Clock Distribution

Document Number: **661M05**

Title: 661FX-1 HOST & AGP

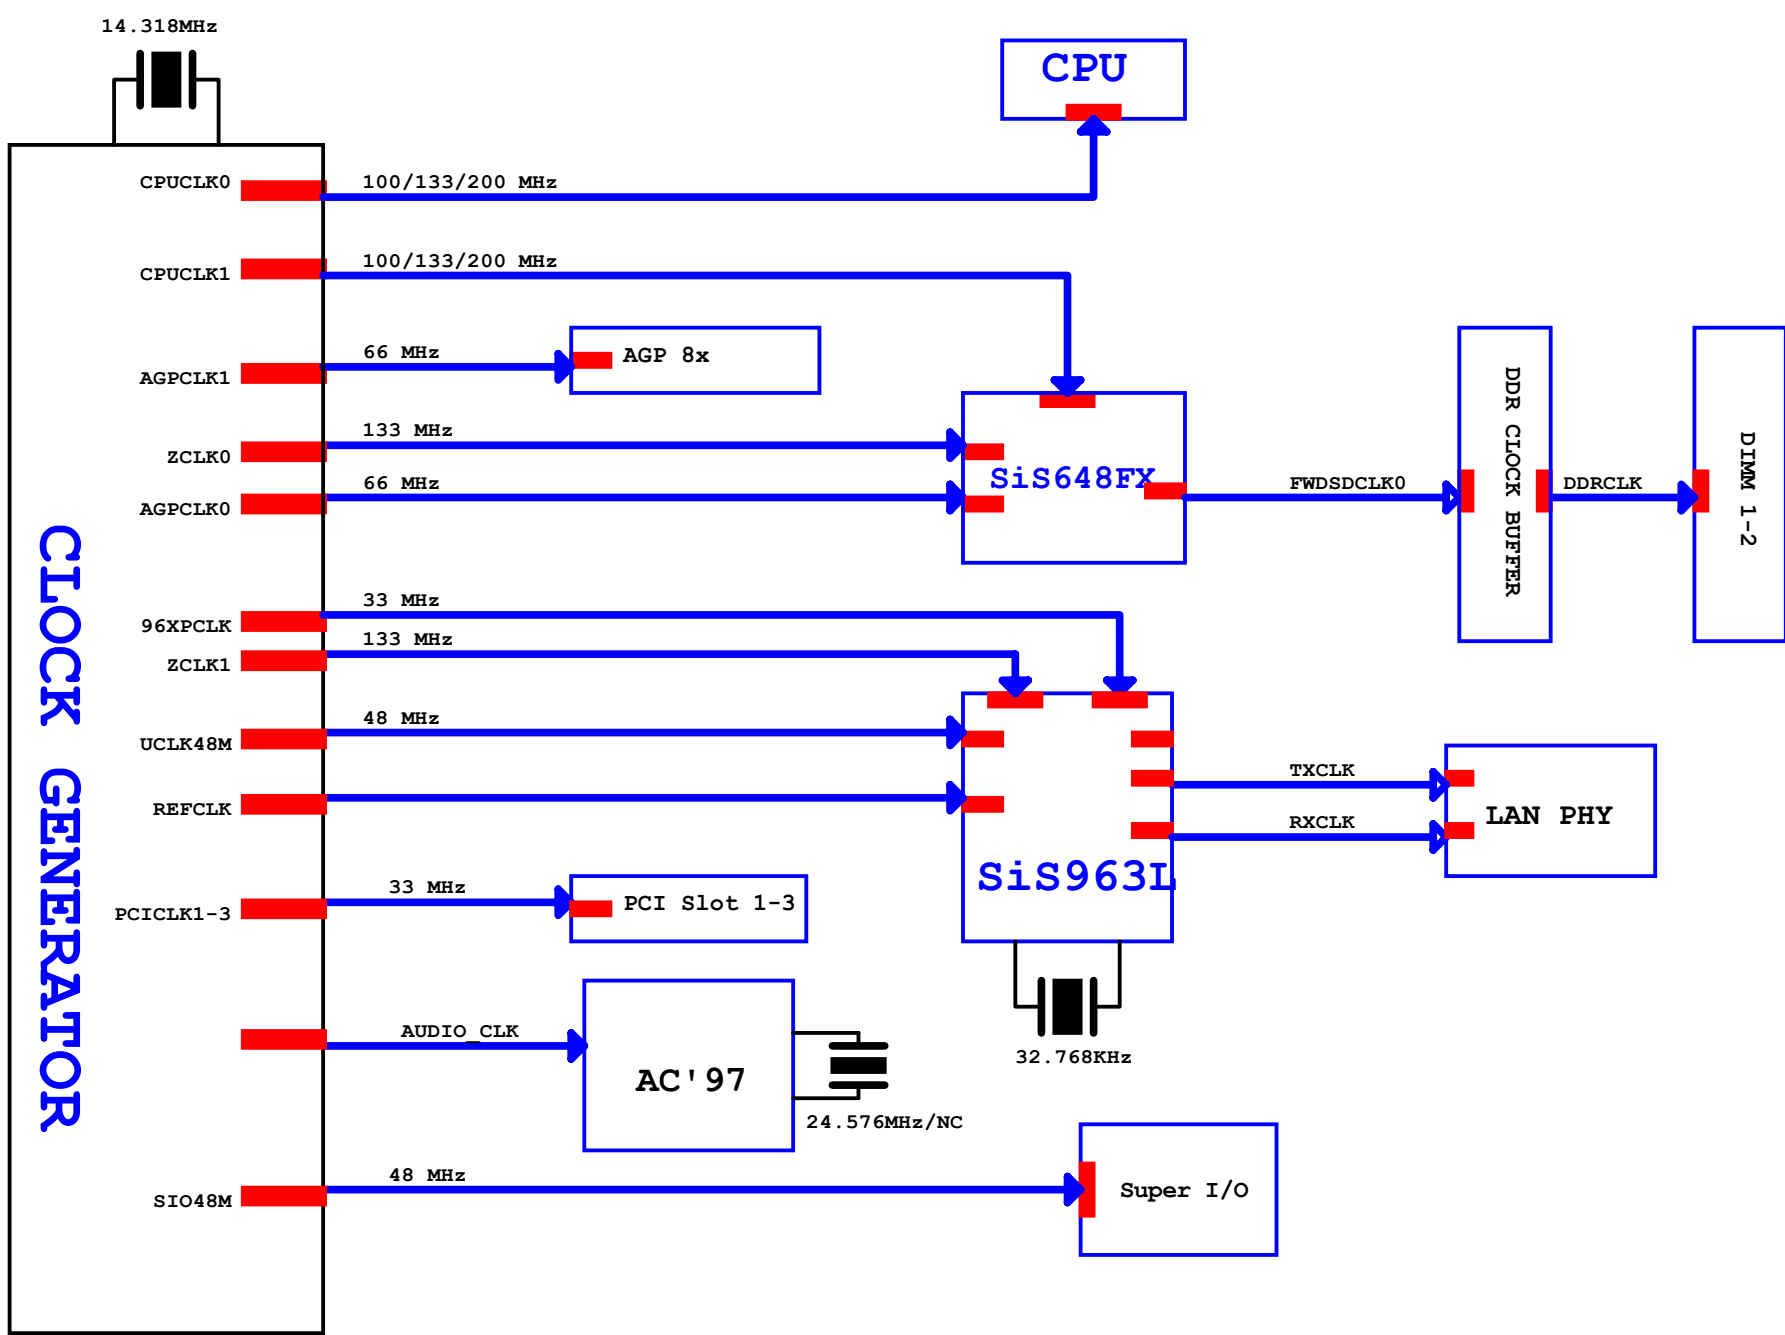
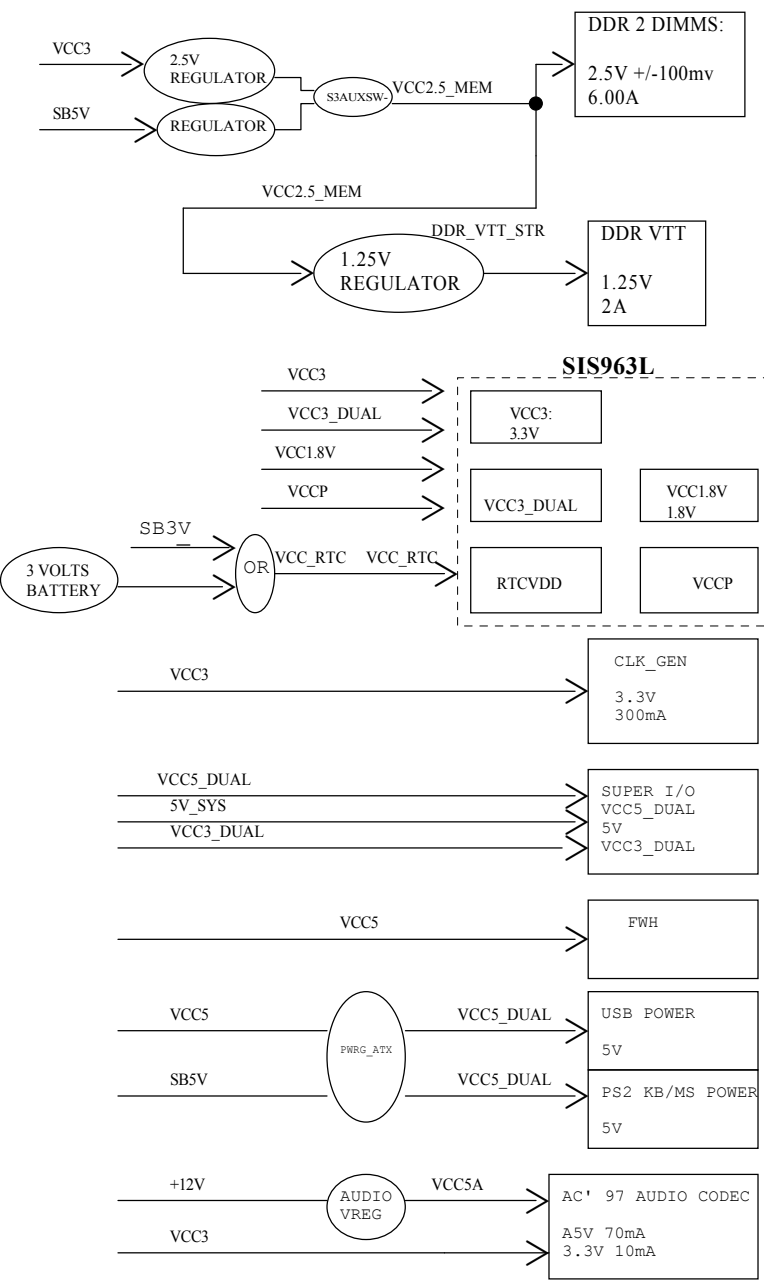
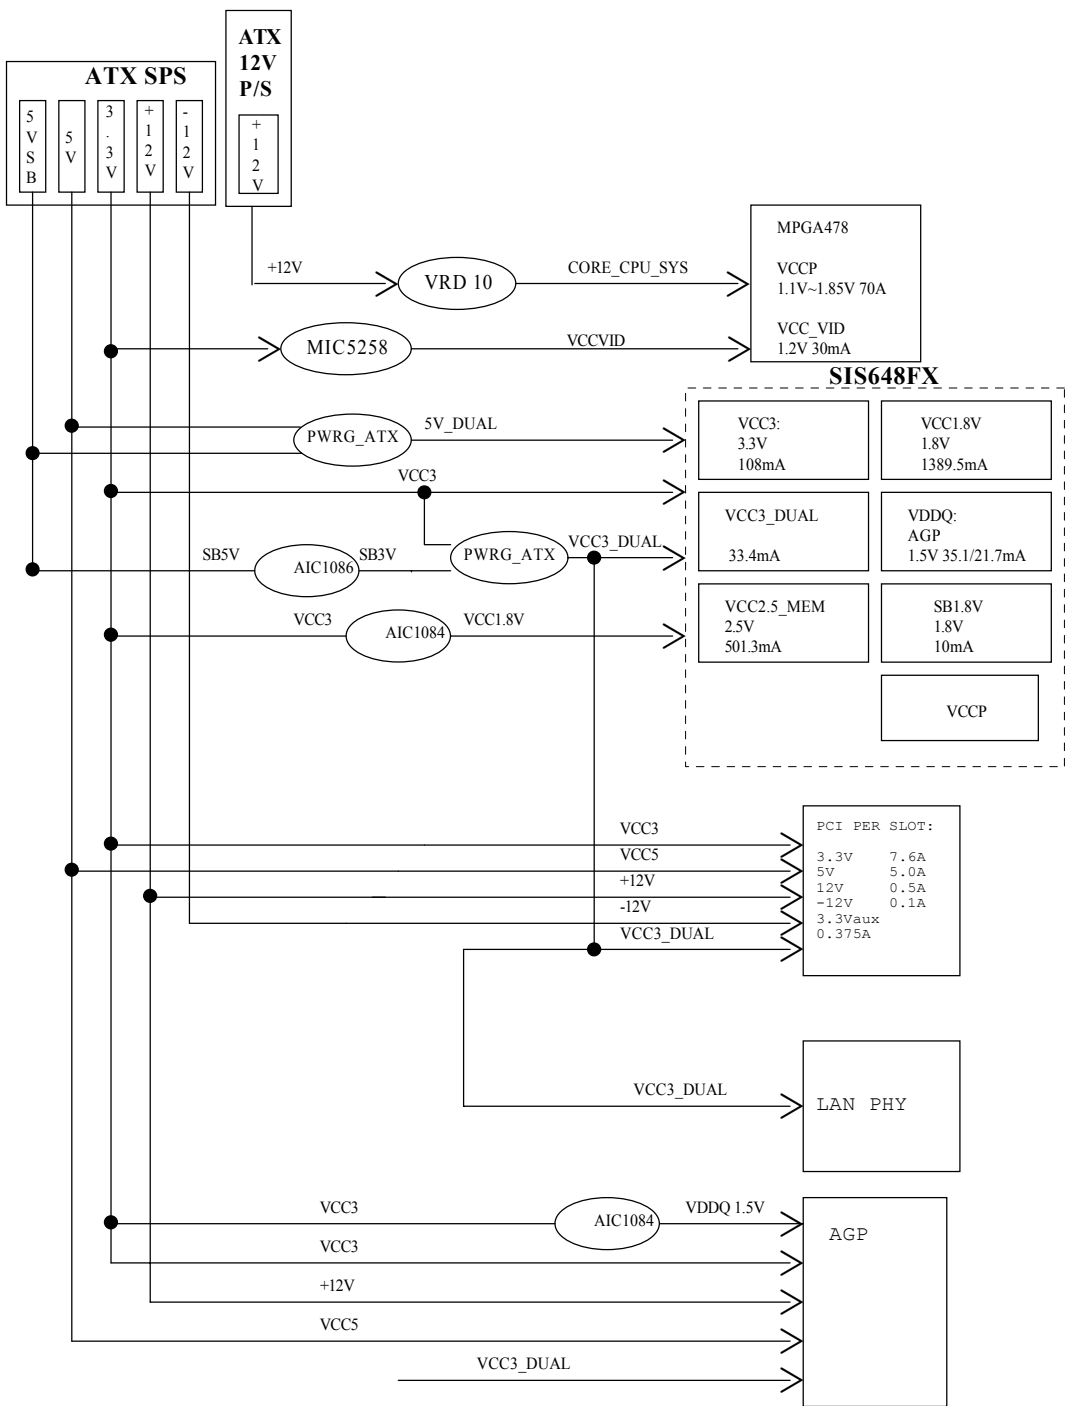
note: 7/6-change termination 49.9 to R8702 4)

Intel Pull High RES 49.9ohm.

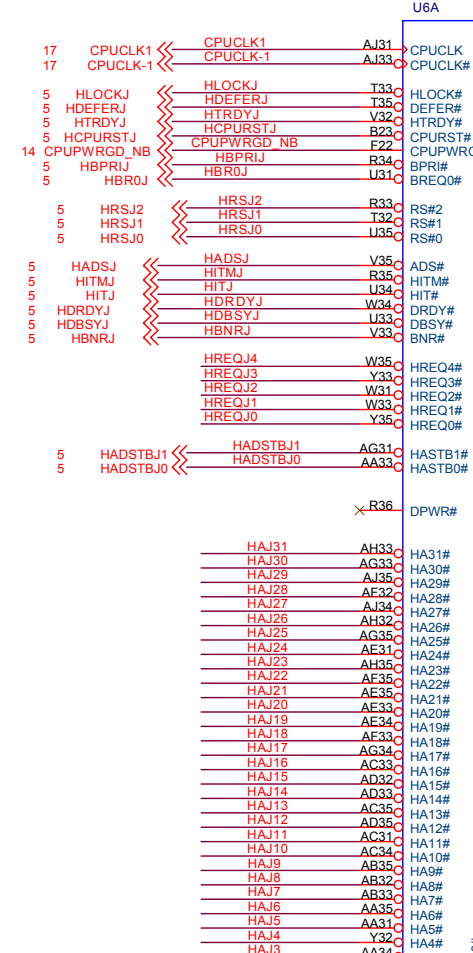
BC48, BC49 Change to 0.1uF?

Title: 964_2

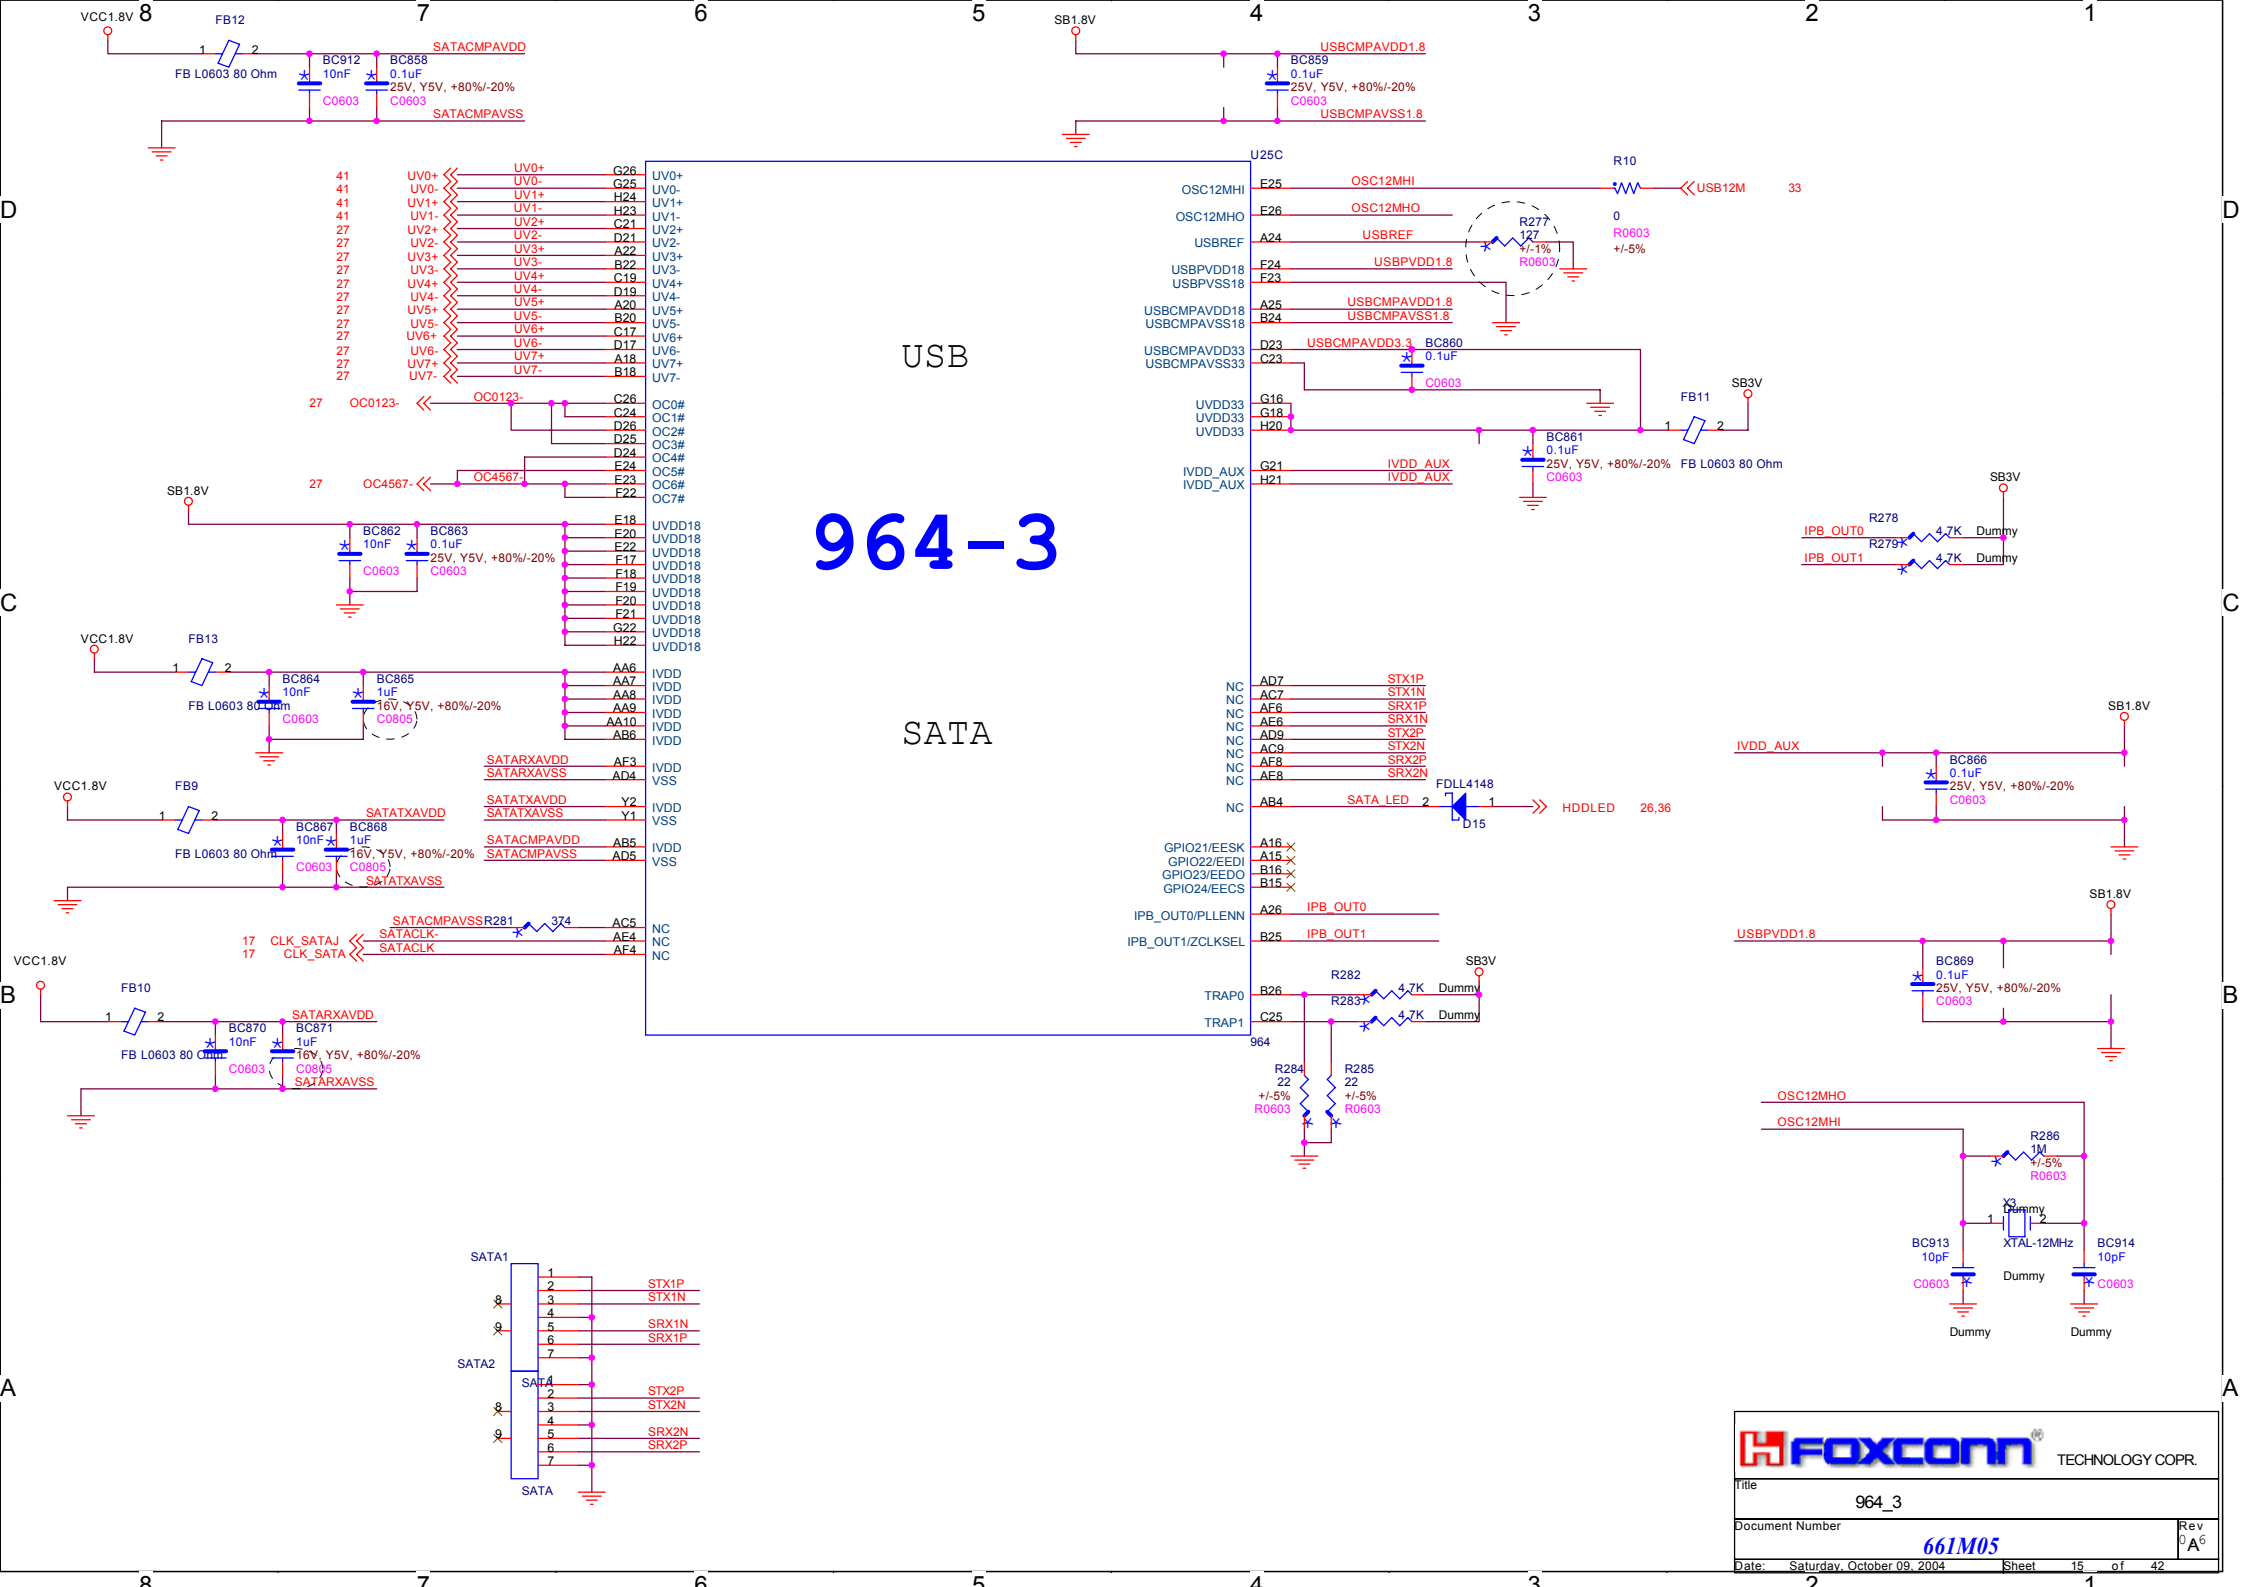
Q31 change from 2N7002 to MMBT3904; Add R10

SSTL-2 Termination Resistors

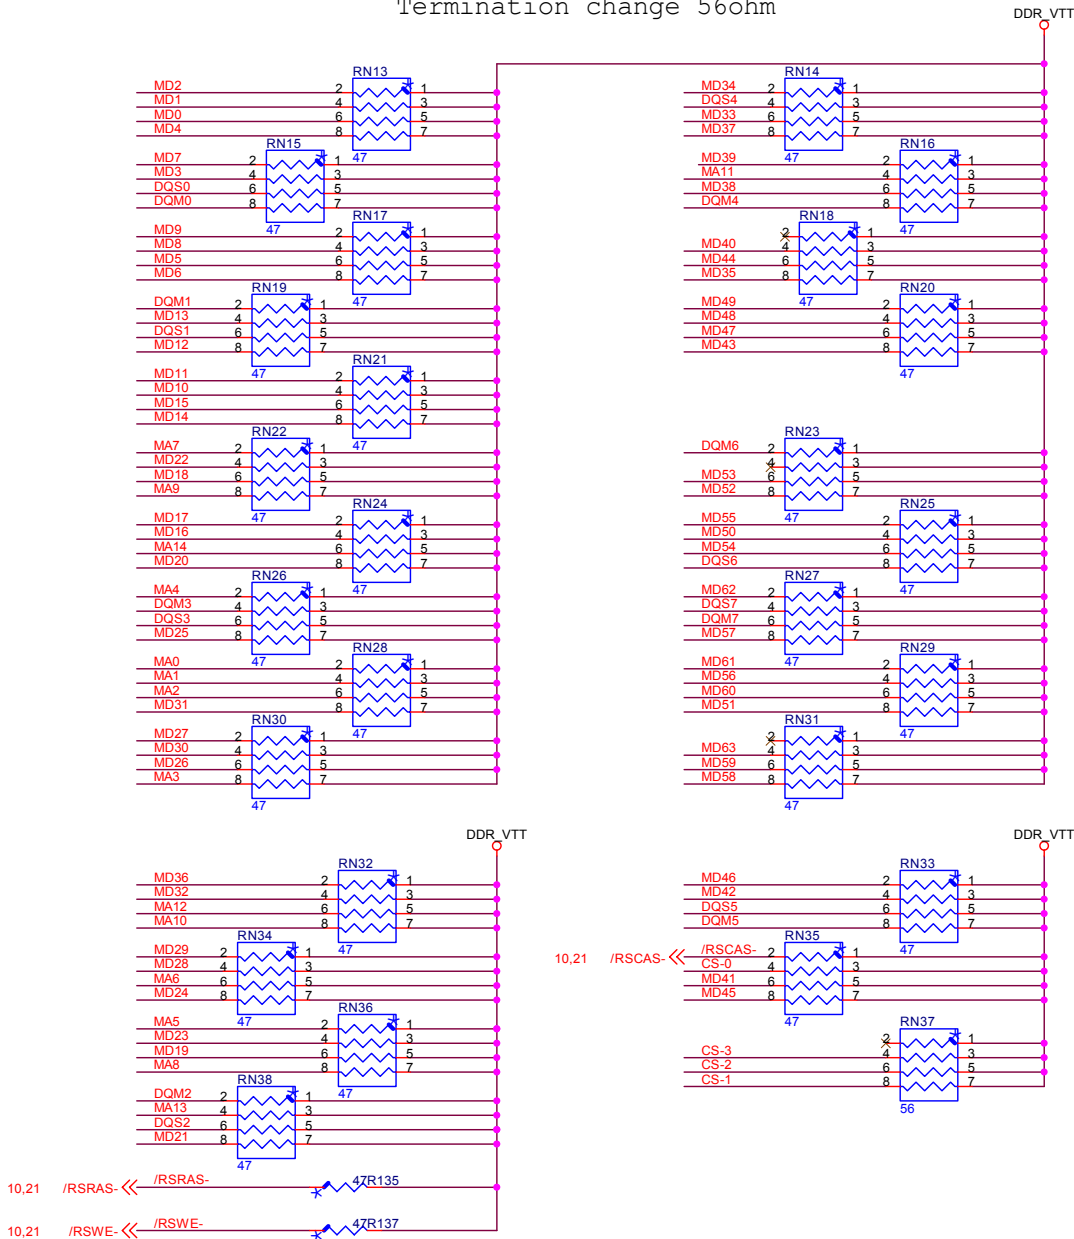
Termination change 56ohm
